REMARKS

Claims 1-3, 5-10, 16, 19, and 20 were rejected over U.S. Patent No. 6,433,787 to Murphy (hereinafter "Murphy") in view of U.S. Patent No. 6,574,689 to Zaidi et al. (hereinafter "Zaidi") and U.S. Patent No. 5,884,099 to Klingelhofer (hereinafter "Klingelhofer"). In response thereto, Applicant respectfully traverses this rejection as to the currently pending claims. While the Office Action rejected

FIG. 1a

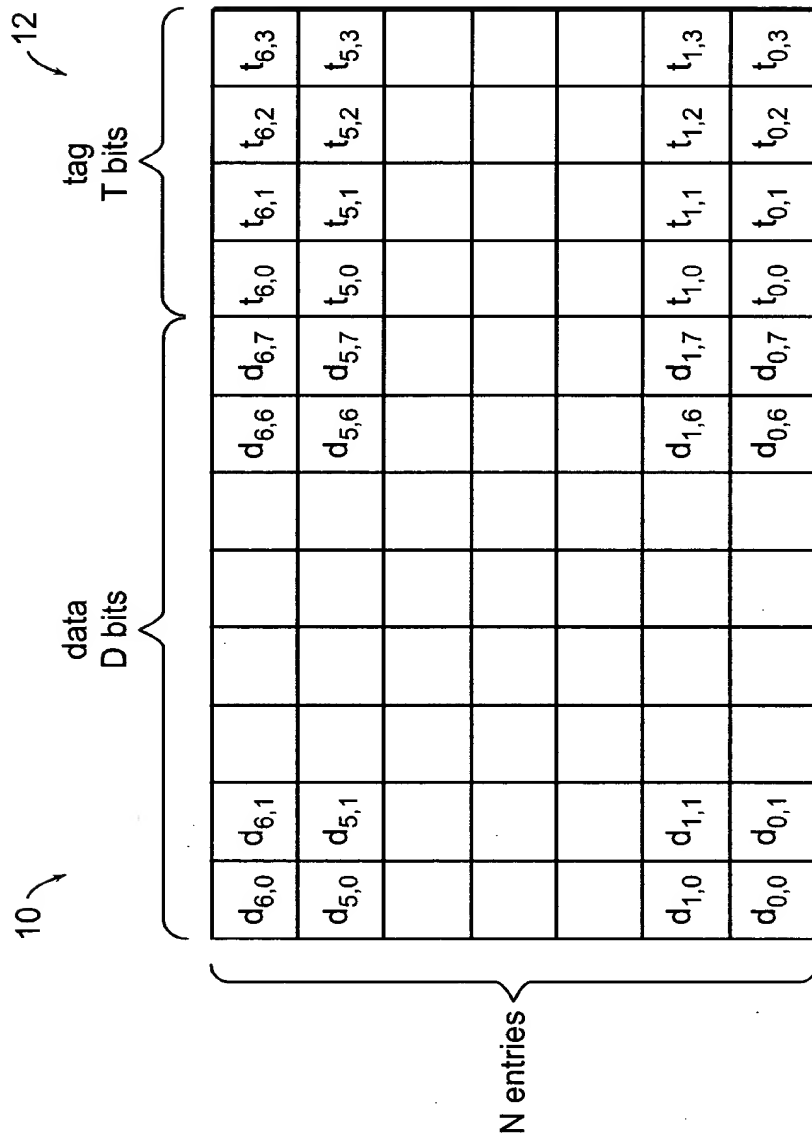
Objections were lodged against the drawings for various reasons. For example, Figs. 1a and 1b were objected to as not containing the term "Prior Art." In citing MPEP § 608.02(g), the Office Action alleges that Figs. 1a and 1b only show that which is old. Applicant disagrees. While Applicant admits that a storage location within a FIFO can contain both data bits and tag bits, Fig. 1a indicates a specific number of tag bits, for example, and Fig. 1b indicates the values within certain tag bit locations can be compared within an exclusive OR gate 14 (Drawings -- Figs 1a and 1b). Nowhere is there any suggestion in the "Background" section of the specification or otherwise that the illustrated number of tag bits and the combination of tag bits using a logic gate is/are deemed prior art. The only reference to "typical" is in the "Brief Description" portion of the specification when referencing a storage device, such as a FIFO buffer. Applicant does not deny that a FIFO is a typical storage device, but otherwise respectfully traverse any suggestion that Figs. 1a and 1b should be designated as "Prior Art." If, however, the Examiner can find a drawing in a prior art reference identical to that of Figs. 1a and 1b, then Applicant

will designate the drawings as "Prior Art." With regard to Fig. 2, formal drawings are submitted herewith to obviate this objection.
